Rezoning Application: PD 25-0143
Zoning Hearing Master Date: March 24, 2025
BOCC Public Hearing Date: May 13, 2025

**Hillsborough
County Florida**

Development Services Department

1.0 APPLICATION SUMMARY

2.4 Proposed Site Plan (partial provided below for size and orientation purposes. See Section 8.0 for full site plan)

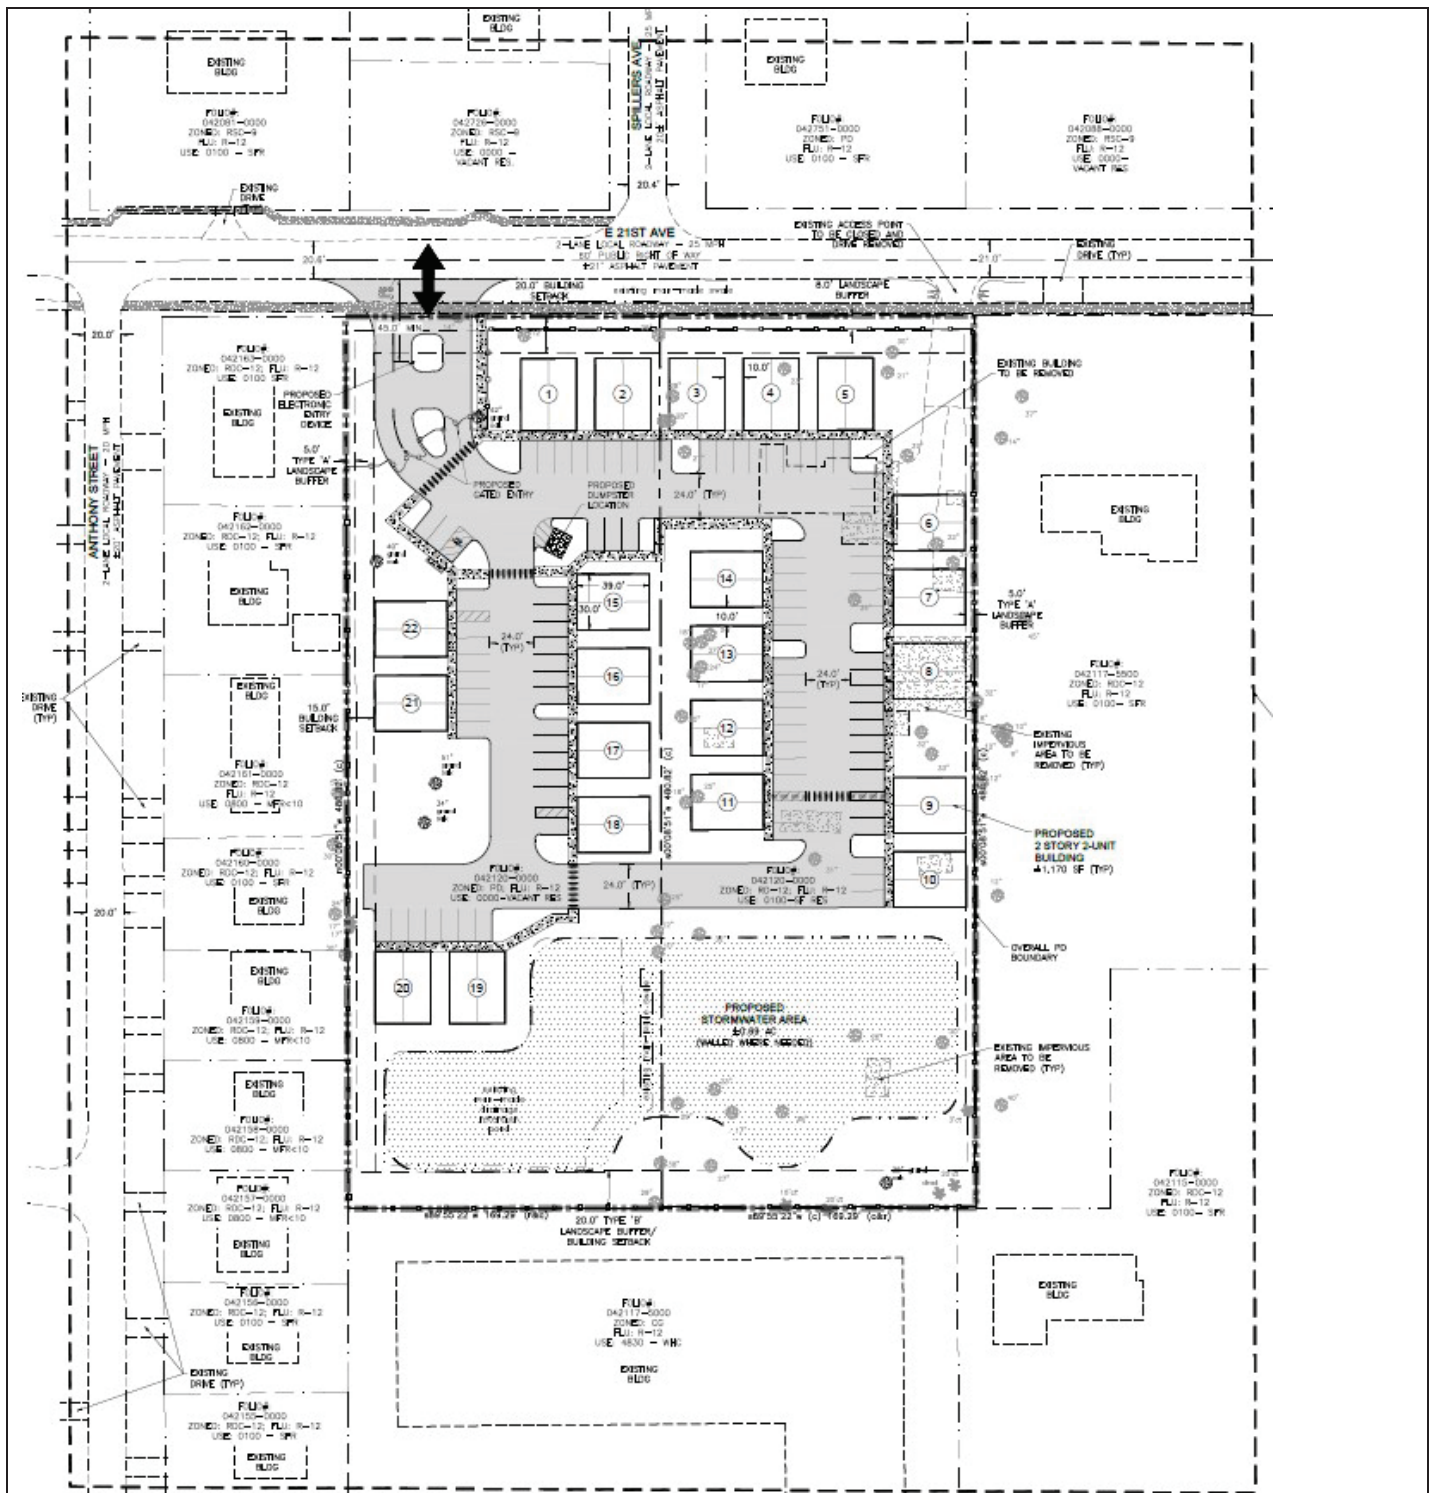
1. Rename the western and eastern “buffers” to “easements.”
